MEMORANDUM

To: Design Review Board
From: Angela Ruggeri, Senior Planner
Date: March 8, 2018
File No.: DRV15-01462
Subject: **KIRKLAND URBAN (PARKPLACE) MIXED USE DEVELOPMENT
MINOR MODIFICATIONS TO APPROVED PLANS**

KIRKLAND PARKPLACE

DESIGN UPDATES
MARCH 8, 2018

BLANK WALL AT SITE ENTRY

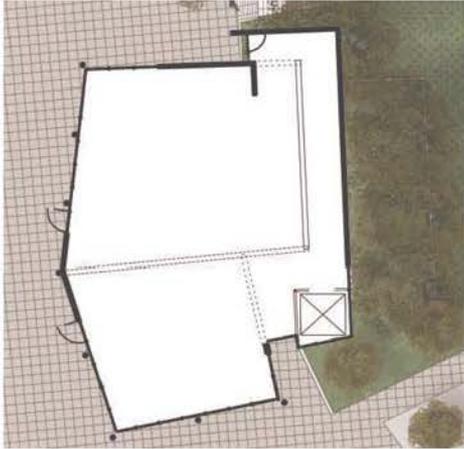
1 CUSTOM PERFORATED CORTEN CLADDING AT CONCRETE GARAGE WALL REPLACED WITH A COMBINATION OF INCREASED PLANTING AGAINST EXPOSED CONCRETE, AND CLADDING OF ALUMINUM PERFORATED PANEL

BUILDING B
REVISIONS

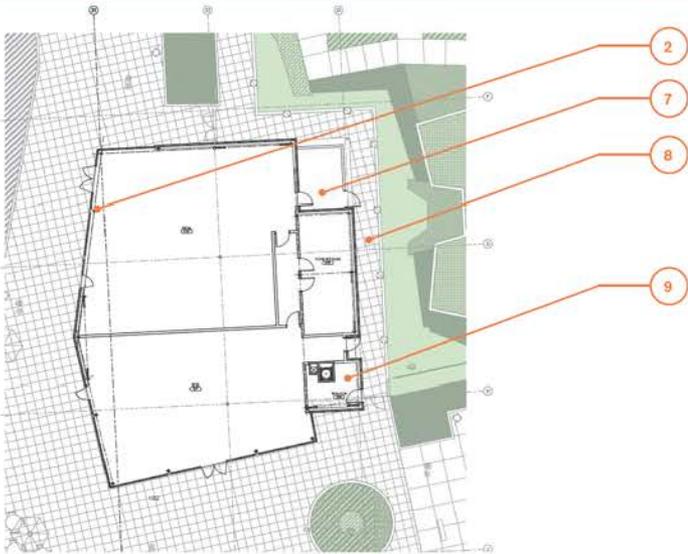
BUILDING B UPDATED PER TENANT REQUIREMENTS.

PREVIOUS EAST ELEVATION

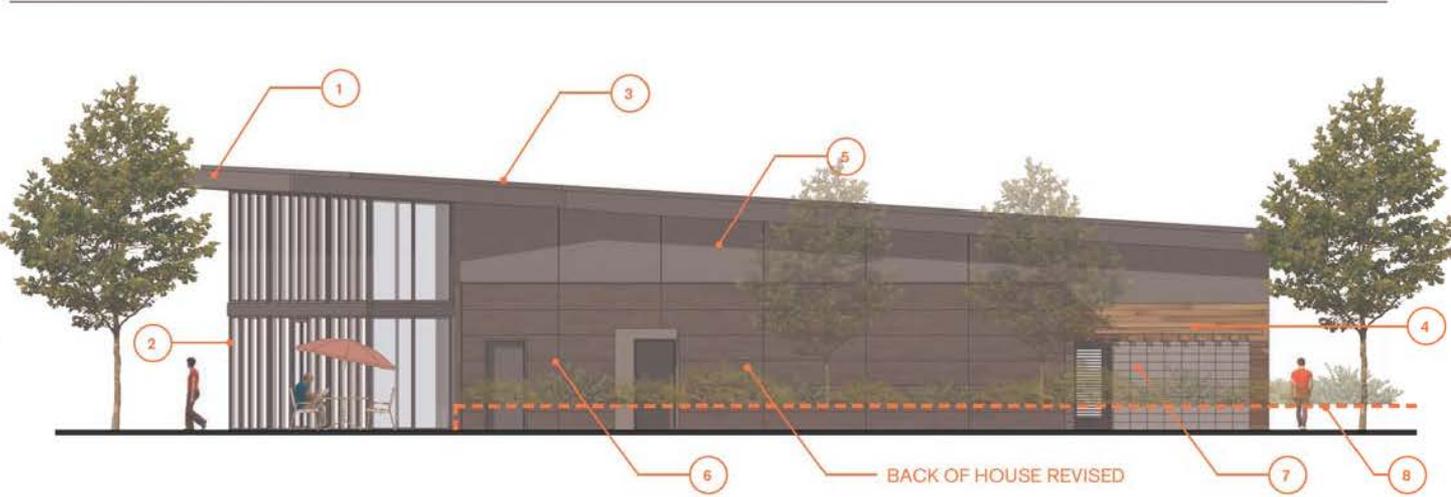
- 1 OVERHANGS REDUCED TO 6 FEET
- 2 COLUMNS MOVED INBOARD
- 3 GREEN ROOF REVISED TO DECORATIVE BALLAST
- 4 WOOD SIDING AND SOFFIT CHANGED TO WOOD LOOK HIGH PRESSURE LAMINATE
- 5 PROFILE METAL PANEL SIDING ADDED TO BREAK UP LARGER SOLID WALLS
- 6 HIGH PRESSURE LAMINATE RAIN SCREEN RETAINED AT LOWER PORTION OF BUILDING
- 7 SCREENED TRASH AREA WITH GROUND FACE CMU WALLS AND WOOD TRELLIS
- 8 ADDED PATHWAY
- 9 ADDED TRASH CHUTE IN LIEU OF ELEVATOR

BUILDING B
REVISIONS

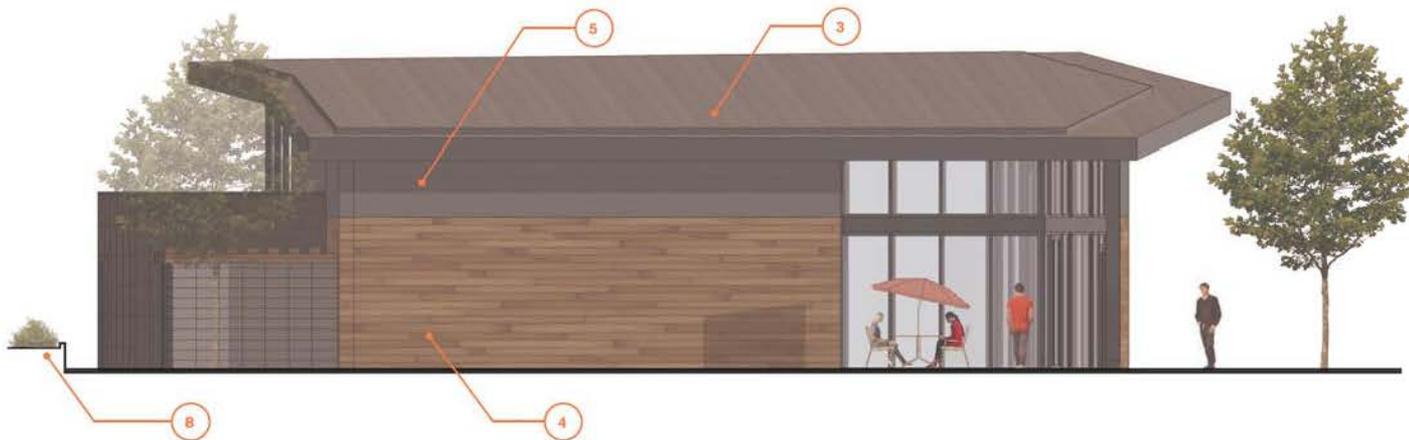
- 1 OVERHANGS REDUCED TO 6 FEET
- 2 COLUMNS MOVED INBOARD
- 3 GREEN ROOF REVISED TO DECORATIVE BALLAST
- 4 WOOD SIDING AND SOFFIT CHANGED TO WOOD LOOK HIGH PRESSURE LAMINATE
- 5 PROFILE METAL PANEL SIDING ADDED TO BREAK UP LARGER SOLID WALLS
- 6 HIGH PRESSURE LAMINATE RAIN SCREEN RETAINED AT LOWER PORTION OF BUILDING
- 7 SCREENED TRASH AREA WITH GROUND FACE CMU WALLS AND WOOD TRELLIS
- 8 RETAINING WALL WITH PLANTING

PREVIOUS VIEW FROM WEST

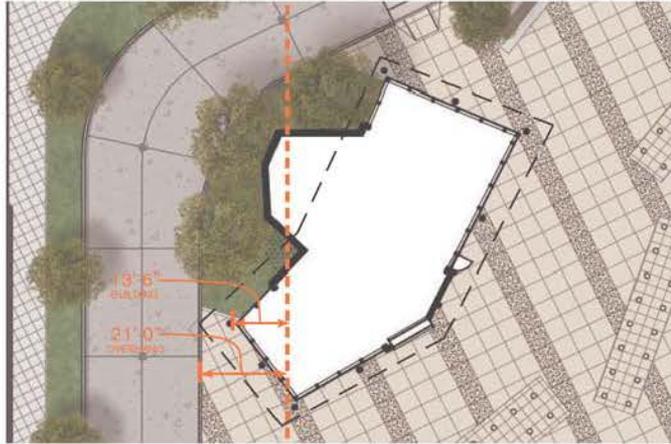
- 1 OVERHANGS REDUCED TO 6 FEET
- 2 COLUMNS MOVED INBOARD
- 3 GREEN ROOF REVISED TO DECORATIVE BALLAST
- 4 WOOD SIDING AND SOFFIT CHANGED TO WOOD LOOK HIGH PRESSURE LAMINATE
- 5 PROFILE METAL PANEL SIDING ADDED TO BREAK UP LARGER SOLID WALLS
- 6 HIGH PRESSURE LAMINATE RAIN SCREEN RETAINED AT LOWER PORTION OF BUILDING
- 7 SCREENED TRASH AREA WITH GROUND FACE CMU WALLS AND WOOD TRELLIS

BUILDING G
REVISIONS

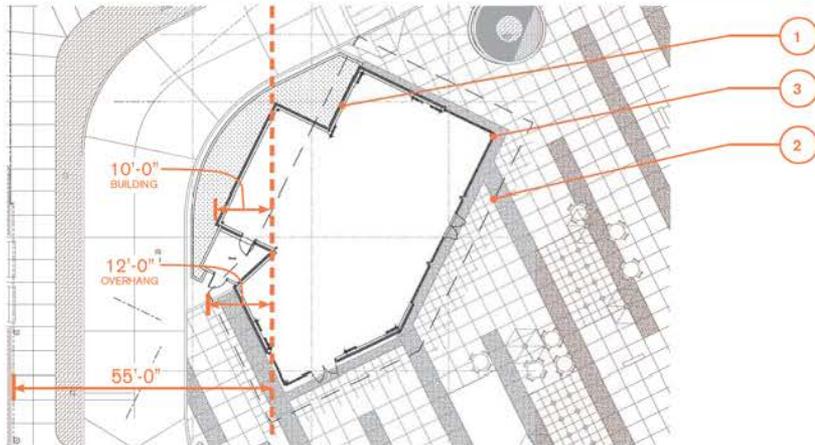
BUILDING G UPDATED PER TENANT REQUIREMENTS.

NOTE: BUILDING G MINOR MODIFICATION REQUEST APPROVED TO ALLOW BUILDING IN 55'-0" SETBACK. CURRENT DESIGN DOES NOT EXCEED APPROVED SETBACK

- 1 WINDOW AREA REDUCED TO PROVIDE RESTAURANT USER MORE BACK-OF-HOUSE SPACE TO ACCOMMODATE KITCHEN LAYOUT
- 2 OVERHANGS REDUCED TO 6 FEET
- 3 COLUMNS MOVED INBOARD
- 4 GREEN ROOF REVISED TO DECORATIVE BALLAST
- 5 WOOD SIDING AND SOFFIT CHANGED TO WOOD LOOK HIGH PRESSURE LAMINATE
- 6 PROFILE METAL PANEL SIDING ADDED TO BREAK UP LARGER SOLID WALLS
- 7 HIGH PRESSURE LAMINATE RAIN SCREEN RETAINED AT LOWER PORTION OF BUILDING
- 8 SCREENED TRASH AREA WITH GROUND FACE CMU WALLS

PREVIOUS EAST ELEVATION

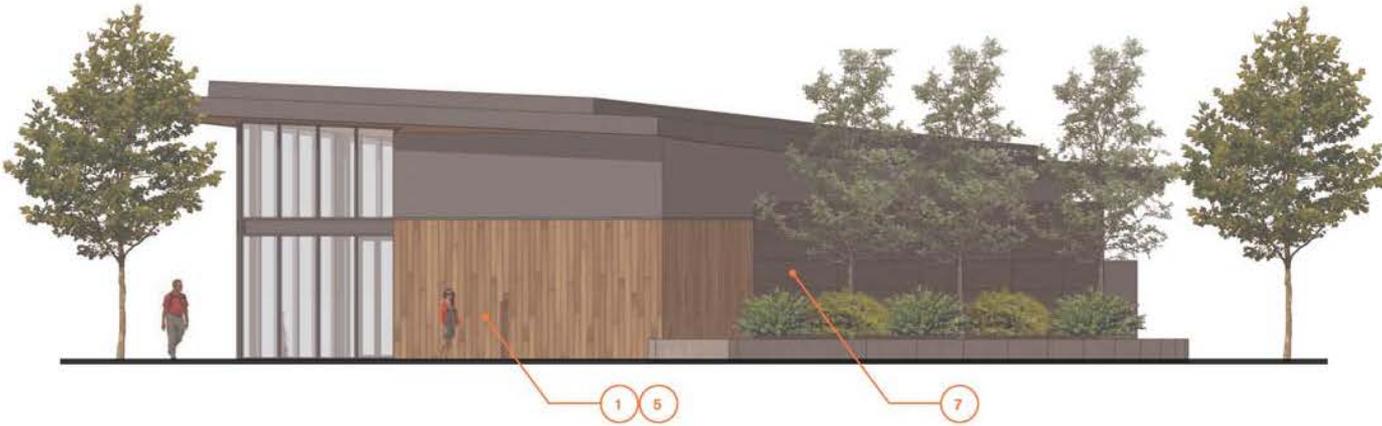
- 1 WINDOW AREA REDUCED TO PROVIDE RESTAURANT USER MORE BACK-OF-HOUSE SPACE TO ACCOMMODATE KITCHEN LAYOUT
- 2 OVERHANGS REDUCED TO 6 FEET
- 3 COLUMNS MOVED INBOARD
- 4 GREEN ROOF REVISED TO DECORATIVE BALLAST
- 5 WOOD SIDING AND SOFFIT CHANGED TO WOOD LOOK HIGH PRESSURE LAMINATE
- 6 PROFILE METAL PANEL SIDING ADDED TO BREAK UP LARGER SOLID WALLS
- 7 HIGH PRESSURE LAMINATE RAIN SCREEN RETAINED AT LOWER PORTION OF BUILDING
- 8 SCREENED TRASH AREA WITH GROUND FACE CMU WALLS

PREVIOUS SOUTH ELEVATION

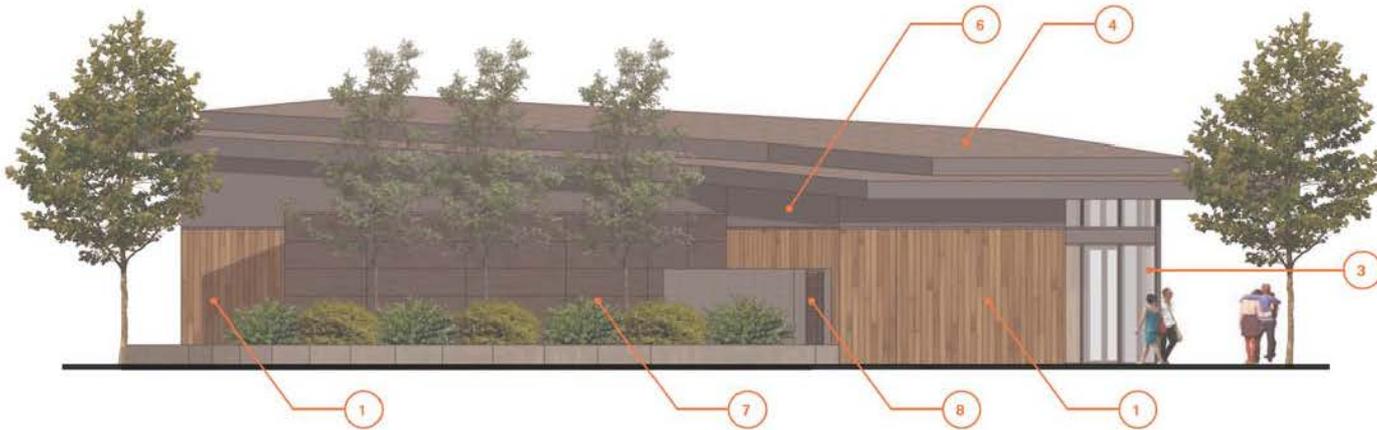
- 1 WINDOW AREA REDUCED TO PROVIDE RESTAURANT USER MORE BACK-OF-HOUSE SPACE TO ACCOMMODATE KITCHEN LAYOUT
- 2 OVERHANGS REDUCED TO 6 FEET
- 3 COLUMNS MOVED INBOARD
- 4 GREEN ROOF REVISED TO DECORATIVE BALLAST
- 5 WOOD SIDING AND SOFFIT CHANGED TO WOOD LOOK HIGH PRESSURE LAMINATE
- 6 PROFILE METAL PANEL SIDING ADDED TO BREAK UP LARGER SOLID WALLS
- 7 HIGH PRESSURE LAMINATE RAIN SCREEN RETAINED AT LOWER PORTION OF BUILDING
- 8 SCREENED TRASH AREA WITH GROUND FACE CMU WALLS

REVISIONS TO SOUTH CURVED FACADE

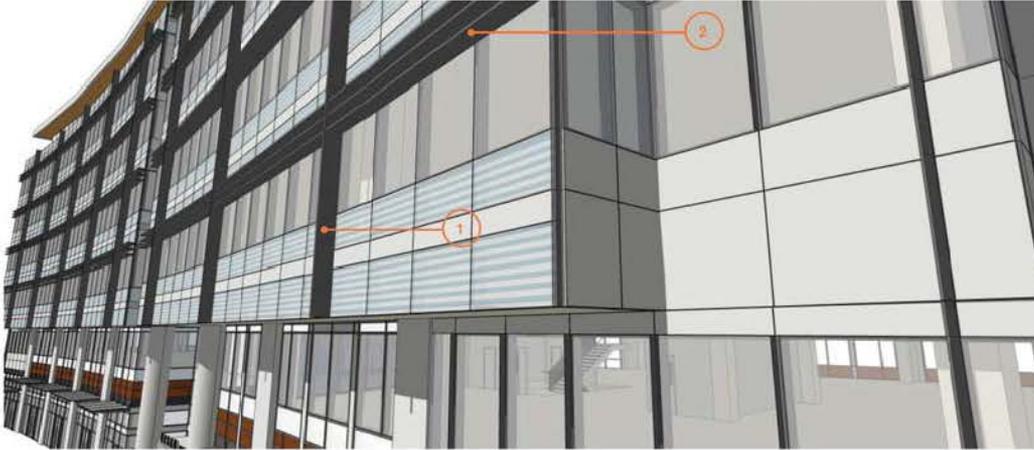
- 1 VERTICAL FINS AT 30' - 0" O.C.
- 2 HORIZONTAL FINS

- 3 VERTICAL FINS AT 10' - 0" O.C. (ALTERNATING PATTERN)

REVISIONS TO SOUTH CURVED FACADE

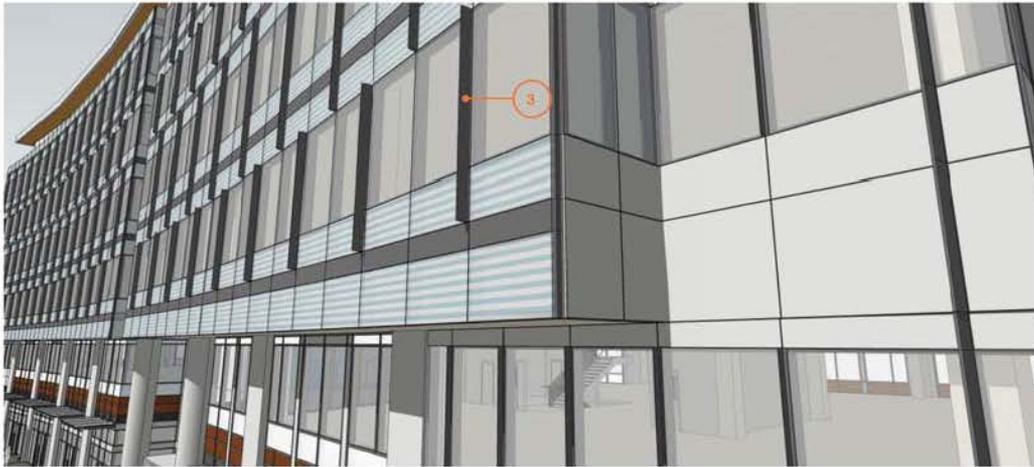
- 1 VERTICAL FINS AT 30' - 0" O.C.
- 2 HORIZONTAL FINS

- 3 VERTICAL FINS AT 10' - 0" O.C. (ALTERNATING PATTERN)
